MICROCHIP PIC18F2420/2520/4420/4520

PIC18F2420/2520/4420/4520 Rev. B2 Silicon Errata

The PIC18F2420/2520/4420/4520 Rev. B2 parts you have received conform functionally to the Device Data Sheet (DS39631C), except for the anomalies described below. Any Data Sheet Clarification issues related to the PIC18F2420/2520/4420/4520 will be reported in a separate Data Sheet errata. Please check the Microchip web site for any existing issues.

FIGURE 1: SCK PULSE VARIATION USING TIMER2/2

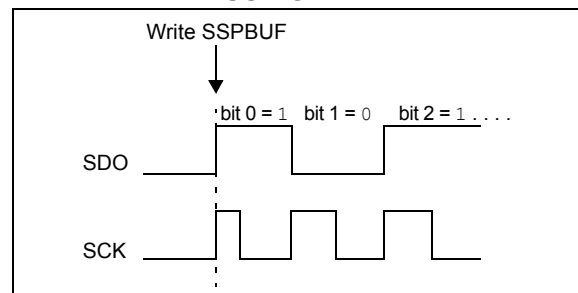
When the SPI is using Timer2/2 as the clock source, a shorter than expected SCK pulse may occur on the first bit of the transmitted/received data (Figure 1).

To avoid producing the short pulse, turn off Timer2 and clear the TMR2 register, load the SSPBUF with the data to transmit and then turn Timer2 back on. Refer to Example 2 for sample code.

```
LOOP BTFSS SSPSTAT, BF ;Data received?  
; (Xmit complete?)  
BRA LOOP ;No  
MOVF SSPBUF, W ;W = SSPBUF  
MOVWF RXDATA ;Save in user RAM  
MOVF TXDATA, W ;W = TXDATA  
BCF T2CON, TMR2ON ;Timer2 off  
CLRF TMR2 ;Clear Timer2  
MOVWF SSPBUF ;Xmit New data  
BSF T2CON, TMR2ON ;Timer2 on
```
